Re: Island View Apartments  
Brock Deck Hand Rail Submittal Review & Special Inspection Report

**To:** Ben Walter @ CWS  
**From:** Todd M. Neal, P.E.  
**Date:** July 23, 2002  
**Subject:** Wo 605 Island View Apartments

**Subject: Building "B" Townhouses, Island View Apartments, Portland, Maine  
 Rear Exterior Deck Guardrails**

Mike Nugent  
City of Portland, Maine  
389 Congress Street  
Portland, ME 04101Re: Island View Apartments - Special Inspection Report for Building B  
Brock Deck Guard Rail System Connections

RAILING CONNECTIONS @ ISLAND VIEW APTS.  
INSTALLED MAY 2002

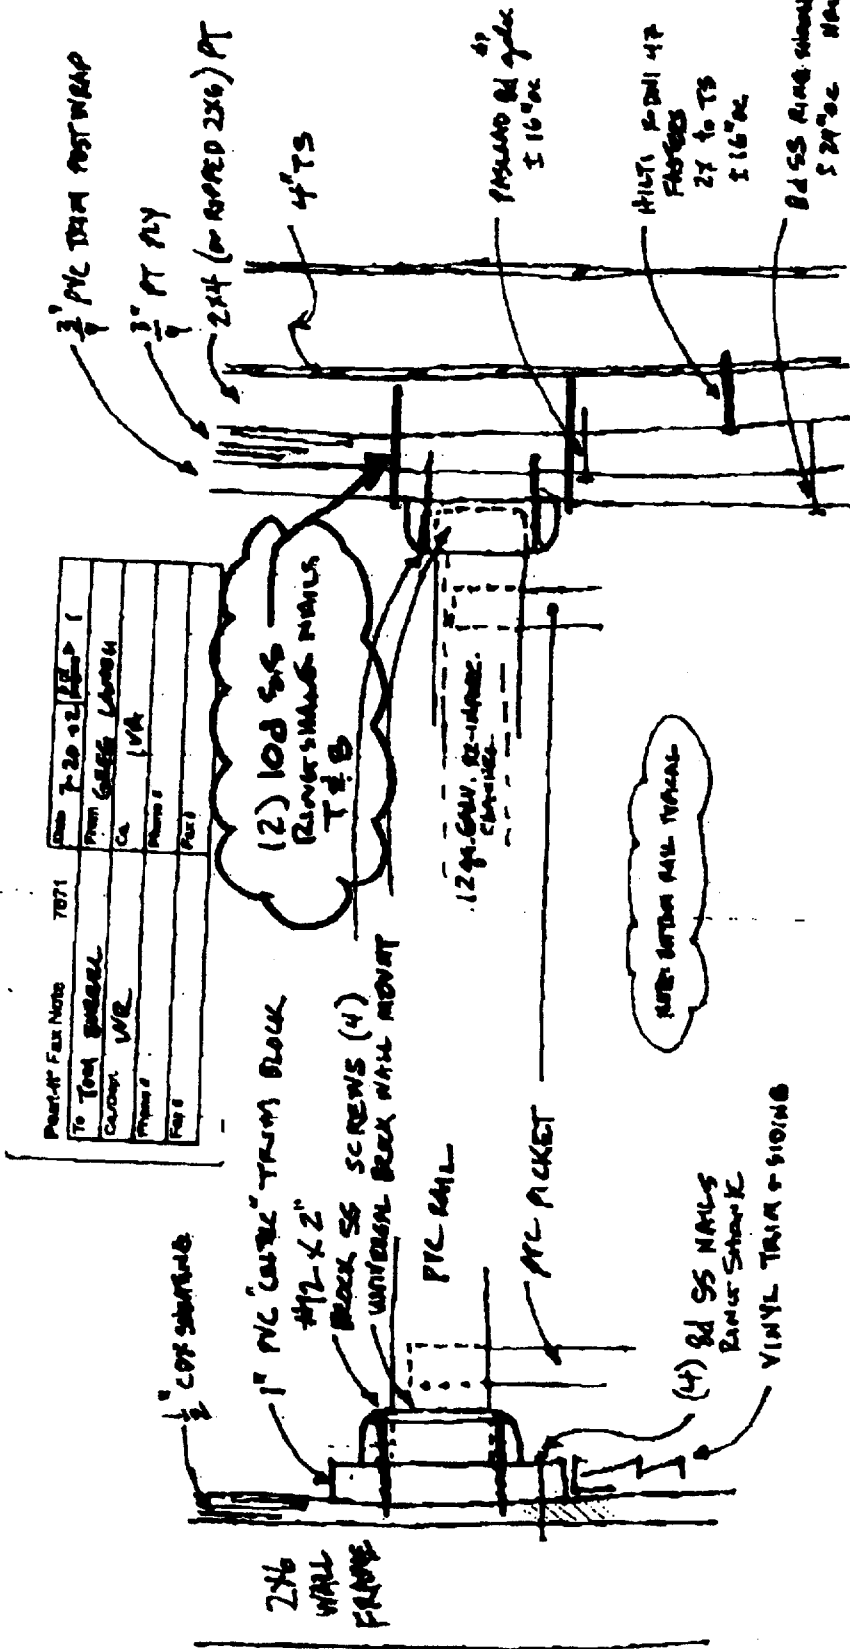
At your request we have reviewed the connection detail of the deck railing system to the building and columns as provided by Wright-Ryan Construction (see attached sketch). We cannot verify this information as the railings and finishes have already been installed.

Based on the information provided on the sketch, including material, connector type and spacing, we have calculated that the detail shown for the connection back to the building meets the design loads of BOCA 1999. The connection of the rail to the columns is undersized and we recommend that 4, 10d stainless steel ring-shank nails are installed around the vinyl wall mount (see attached sketch). These additional fasteners will bring the capacity of the connection up to the requirements of BOCA 1999

(2) 10D SS RING-SHANK NAILS T & B
